MEMORANDUM

RE: Lincoln Hall Large Group Instruction Room 205

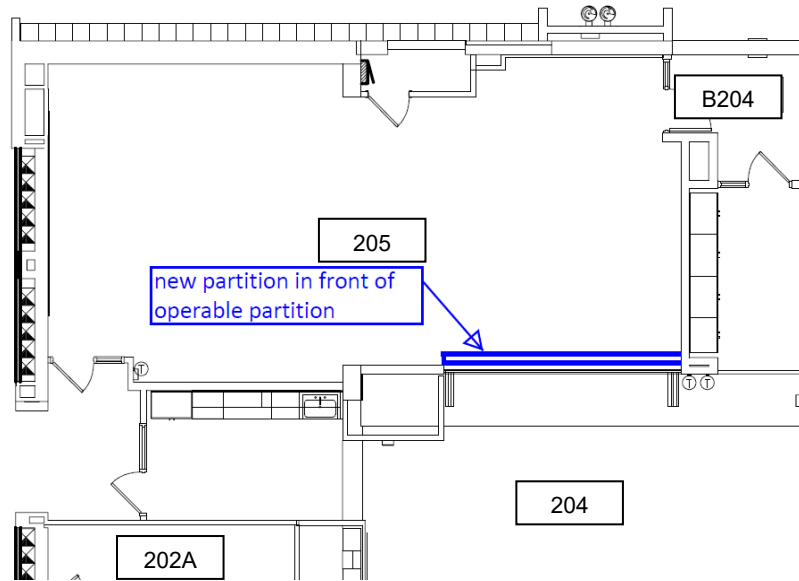
The operable glass partition that separates the 2 spaces is the weakest link for sound transmission between the two rooms. There are various approaches to improvements at this item:

- Option 1: If rooms 205 and 204 will be used as two distinct and separate rooms for the foreseeable future, install a drywall+metal stud+sound batt insulation partition on the room 205 room side which would decommission the operable partition without removing it.
 - Pros:
 - The additional partition will greatly decrease noise transmission between the two rooms, similar to other intermediate partitions between classrooms
 - Partition could function as a temporary installation and could be removed in the future to make the operable partition accessible if the two rooms start functioning as interconnected spaces again
 - Cons:
 - Signage or hardware changes at operable glass partition should be considered to prevent people from using partition.
 - High premium costs for small scope of work
 - Potential cost impact: \$8,500

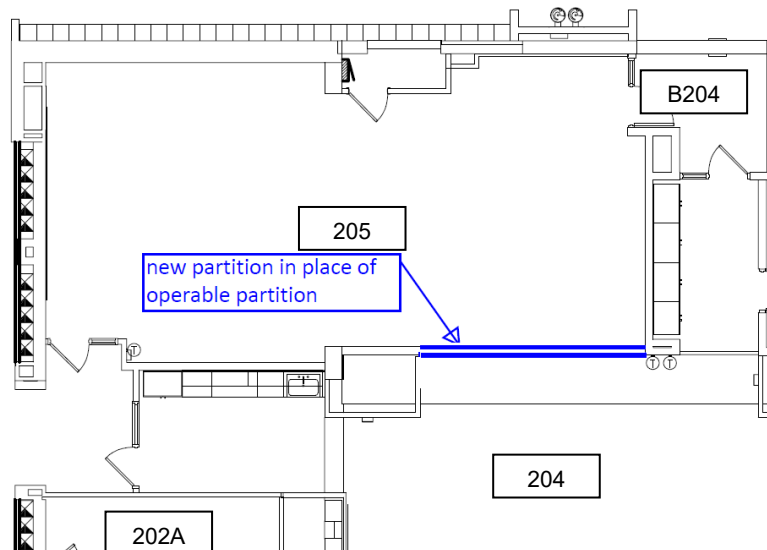
- - Option 2: If rooms 205 and 204 will be used as two distinct and separate rooms for the foreseeable future, remove and salvage the existing operable glass partition. In its place, install a drywall+metal stud+sound batt insulation+drywall partition.
 - Pros:
 - The additional drywall partition will greatly decrease noise transmission between the two rooms, similar to other intermediate partitions between classrooms
 - Steel beam could remain in place to facilitate reinstatement of operable glass partition in the future.
 - Cons:
 - Space on site would need to be found to store the operable glass partition
 - High premium costs for small scope of work
 - Potential cost impact: \$10,000

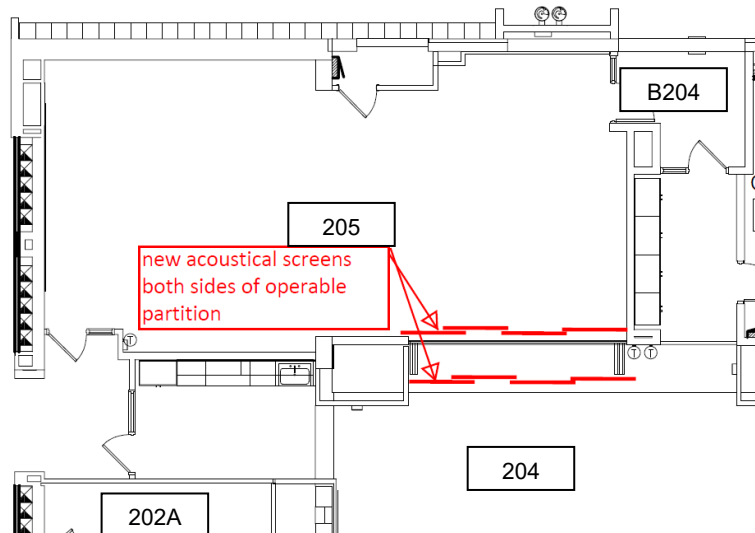
- Option 3: Leave existing operable glass partition in place and install ceiling hung acoustical screens on both sides of the partition. A picture of that type of screen system is included below for reference; there are endless colors and lots of perforation (or solid) patterns that could be considered. The addition of these panels could help absorb some of the noise in each room before it can pass through the operable glass partition to the other room.
 - Pros:
 - Fast installation – can be scheduled for a non-attendance day
 - Can maintain operation of operable glass partition
 - Panels can easily be removed in future
 - Cons:
 - Less of an improvement in noise transmission than Options 1 & 2
 - Potential cost impact: \$13,000 for one room/side; \$26,000 for both rooms/sides
